SERVICE INSTRUCTION

Service Instruction No. 1524
Engineering Aspects are
FAA DER Approved

SUBJECT: Alternator Bracket Kit for 130A Alternators

MODELS AFFECTED: All Lycoming new, overhauled, rebuilt, or repaired IO-360-A1B6, -B1G6, -C1E6, -C1G6, O-360-A1G6, and TIO-360-C1A6D engines.

Figure 1: Illustrative Example of Single Alternator Attaching Bracket

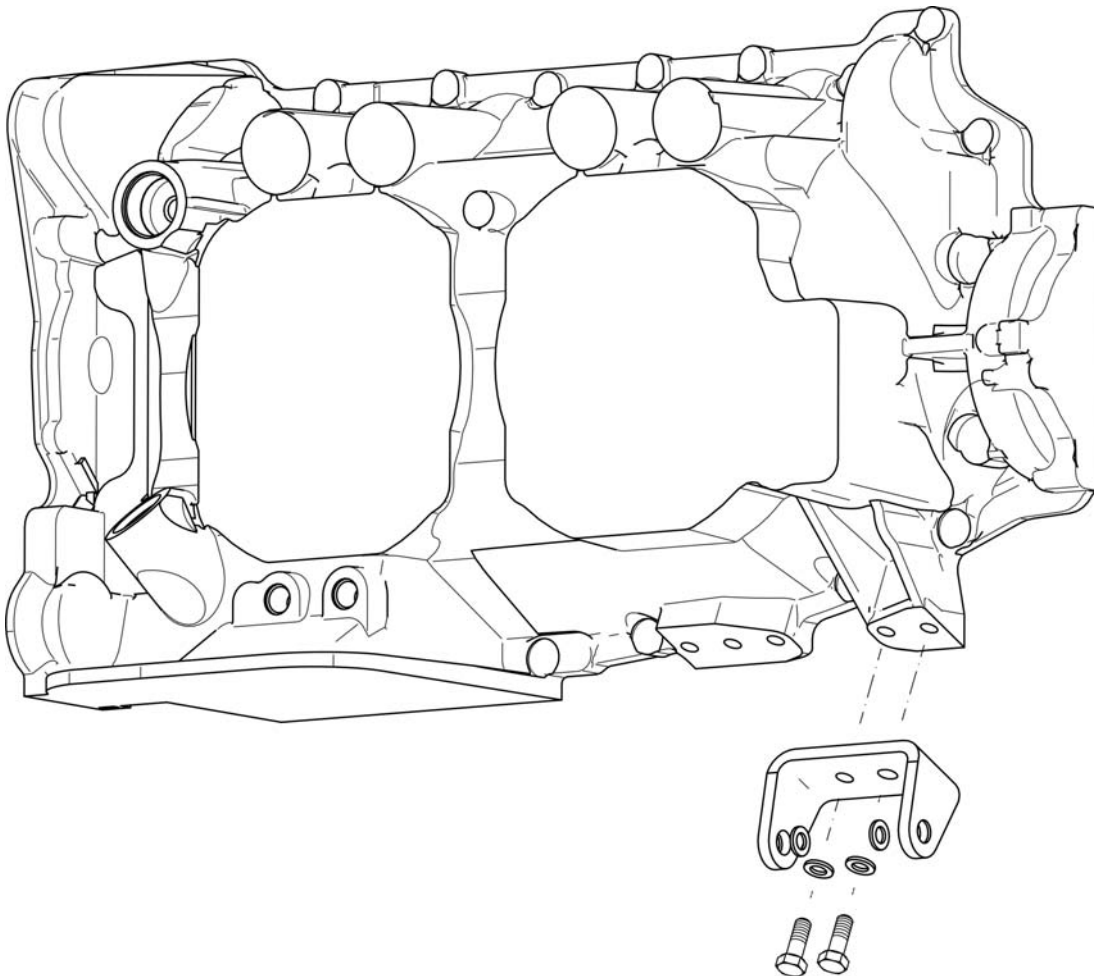
Lycoming has determined that a crack may develop in the crankcase near the alternator attaching bracket on any of the above listed engine models utilizing a 130A alternator assembly and only a single alternator attaching bracket. See Figure 1 for the illustrative example. If the existing bracket is drilled for a .375 in. diameter bolt instead of a .4375 in. diameter bolt, contact Lycoming Engines for a replacement bracket.

Oil may be lost through the crack and subsequent damage to the engine may result. Additionally, Lycoming Engines requires cracked crankcases to be replaced before further flight.

The new Alternator Bracket Kit, P/N 05K26328, has been created to supply additional support components to the existing alternator attaching bracket by installing another bracket between the crankcase and alternator. The kit contains the parts listed below to accomplish this modification in the field.

Figure 2. Installation of Additional Support Components

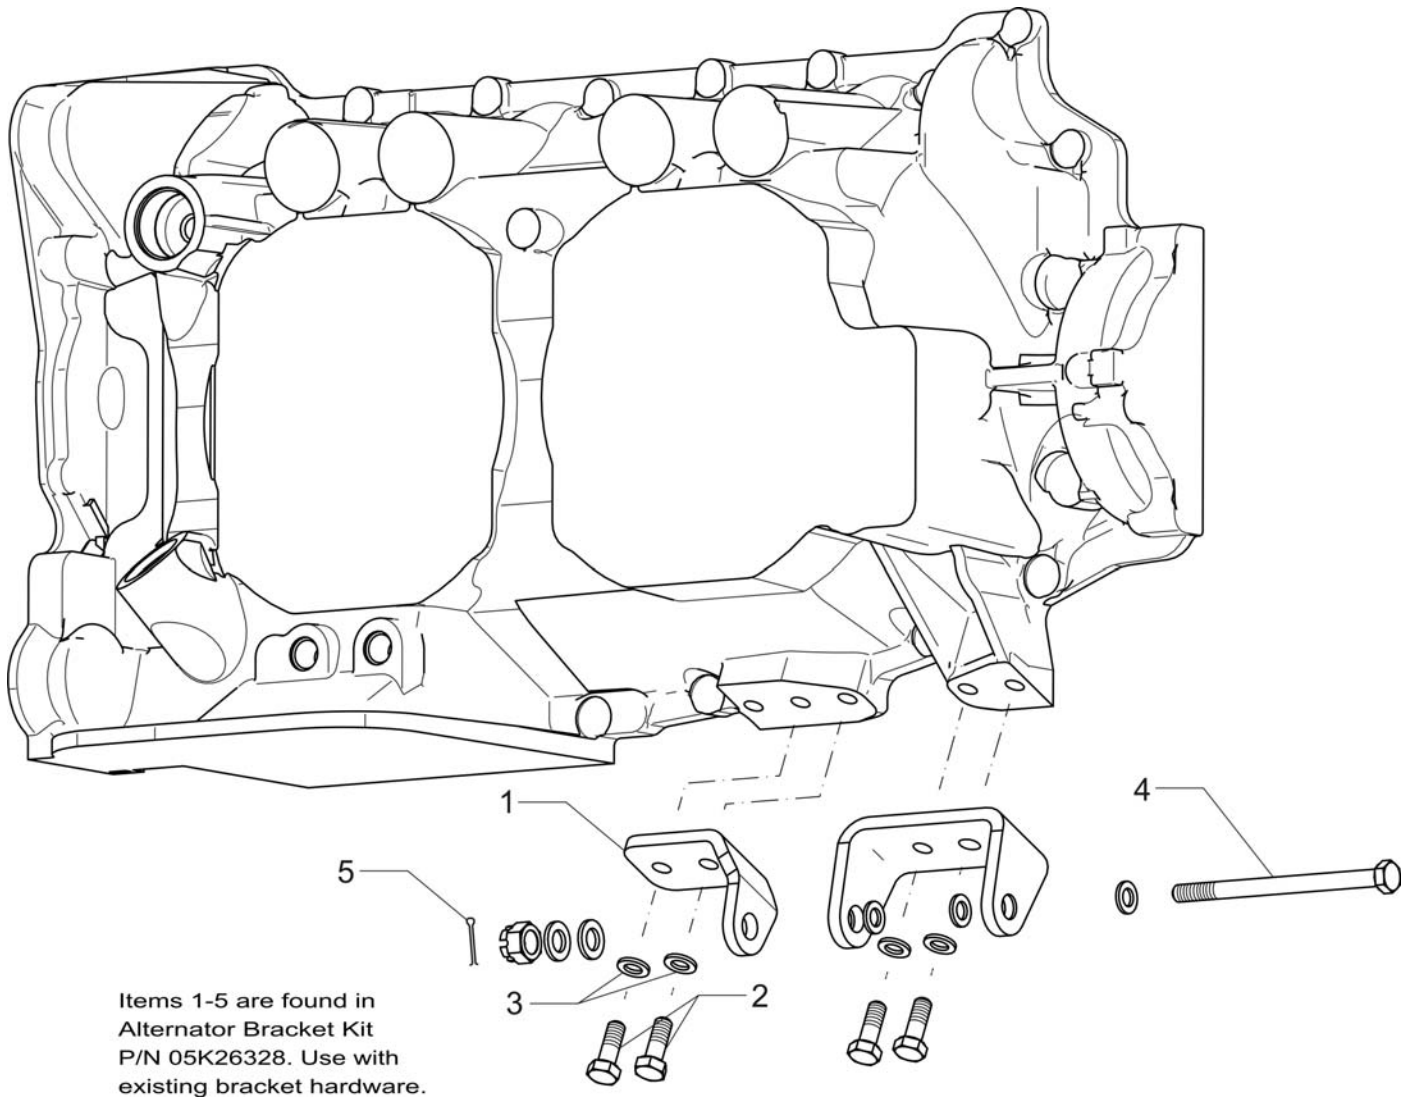
4. Install the additional bracket kit components #1, #2, and #3 as shown in Figure 2. Torque to 17 ft-lbs. and safety wire the bolts per FAA AC 43.13-1B.

5. Reinstall the 130A alternator.
6. Install the new P/N AN7-44 bolt through the existing alternator bracket, shims, washers, and new bracket P/N 07A26130 and torque to 17 ft-lbs. Install the cotter pin, P/N STD-713 through the castellated nut.
